UNITED STATES PATENT AND TRADEMARK OFFICE

APPLICATION NO.	FILING DATE	FIRST NAMED INVENTOR	ATTORNEY DOCKET NO.	CONFIRMATION NO.
10/666,595	09/18/2003	Elliott Malcolm Philofsky	ACR-0301	8539
7590	08/11/2004		EXAMINER	
Law Office of Dale B. Halling, LLC Suite 311 24 South Weber Street Colorado Springs, CO 80903			THOMAS, ERIC W	
			ART UNIT	PAPER NUMBER
			2831

Office Action Summary

FIG. 4

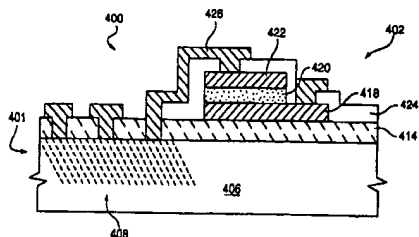
McMillan et al. disclose in fig. 4, a capacitor comprising a first nickel electrode (col. 2 lines 59-63 – 418), a BCTZ dielectric (420 – col. 5 lines 20-40), and a second electrode (422) sandwiching the BCTZ, wherein the first nickel electrode, the BCTZ dielectric and the second electrode are contained within a bump of an integrated circuit.

McMillan et al. disclose the claimed invention except for the second electrode is formed from a nickel.

Uemoto et al. teach that it is known in the capacitor art to form electrodes from nickel.

It would have been obvious to a person of ordinary skill in the art at the time the invention was made to form the top electrode of McMillan et al. using a nickel material as taught by Uemoto et al., since nickel is an inexpensive material that has good electrical conductivity.

Regarding claim 2, McMillan et al. disclose the BCTZ contains one hundred atoms of barium per zero atoms of calcium (or BaTiZrO₃ – as suggested in col. 5 lines 25-40).

Regarding claim 3, McMillan et al. disclose the claimed invention except for the BCTZ contains eighty two to ninety atoms of titanium for each ten to eighteen atoms of zirconium. It would have been obvious to one having ordinary skill in the art at the time the invention was made to form the BCTZ to contain eighty two to ninety atoms of titanium for each ten to eighteen atoms of zirconium, since it has been held that, where the general conditions of a claim are disclosed in the prior art, discovering the optimum or workable ranges involves only routine skill in the art. *In re Aller*, 105 USPQ 233.

Regarding claim 4, McMillan et al. disclose the first nickel electrode is adjacent to a lead (as illustrated in fig. 4 – not labeled).

McMillan et al. do not disclose that the lead is formed from an aluminum material. It should be noted that McMillan et al. teach that a lead connected to the second electrode is formed from an aluminum material. It would have been obvious to one having ordinary skill in the art at the time the invention was made to form the lead connected to the first electrode from an aluminum material, since it has been held to be within the general skill of a worker in the art to select a known material on the basis of its suitability for the intended use as a matter of obvious design choice, and aluminum is an inexpensive material. *In re Leshin*, 125 USPQ 416.

Regarding claim 5, McMillan et al. disclose the second electrode is electrically connected to a second aluminum lead (426) on the integrated circuit.
